BID ADDENDUM NO. 1

Date of Addendum: October 11, 2023
Issued for Bid Date: September 22, 2023
Client Name: Mount Pleasant Central School District
Project Name: 2022 WMS Makerspace and PPS Project
SED Project No.: Westlake Middle and High School: 66-08-01-06-0-005-025, 006-015
MEMASI Project No.: 107-2201
Contracts: Contract No. 1 – General Construction (GC)
Contract No. 2 – Mechanical Construction (MC)
Contract No. 3 – Electrical Construction (EC)
Contract No. 4 – Window Construction Work (WC)

OVERALL PLAN - PUPIL PERSONNEL SERVICES

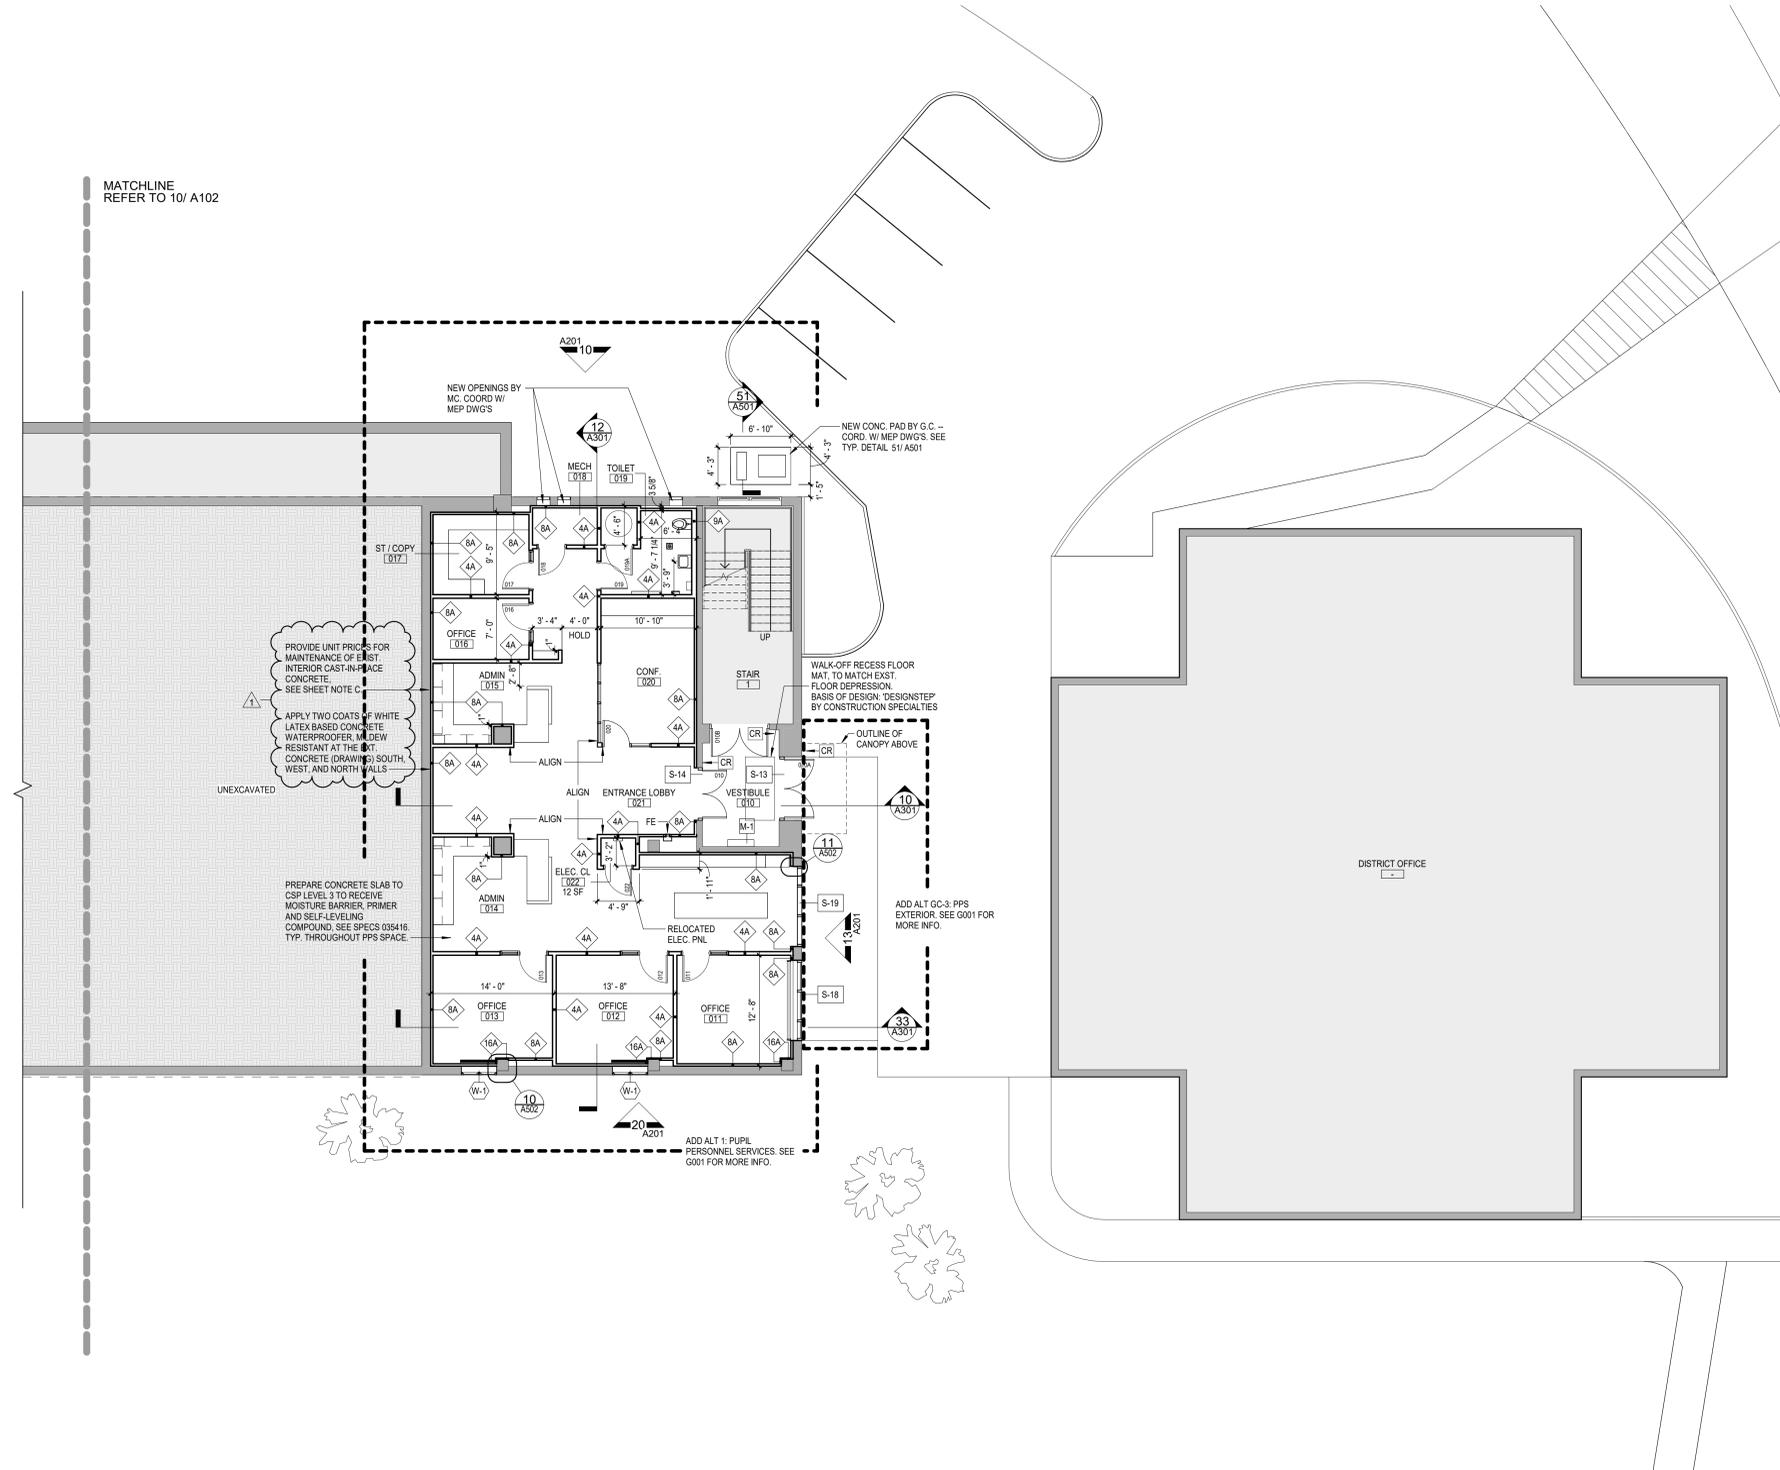
1. A101 – OVERALL PLAN – PUPIL PERSONNEL SERVICES

- a. Sheet Note C. Rapid strengthening cementitious patching mortar basis of design.
- b. Drawing 10. Two notes were added to provide Unit Price for maintenance of delaminating cast-in-place concrete and apply Latex based waterproofing at interior concrete walls.
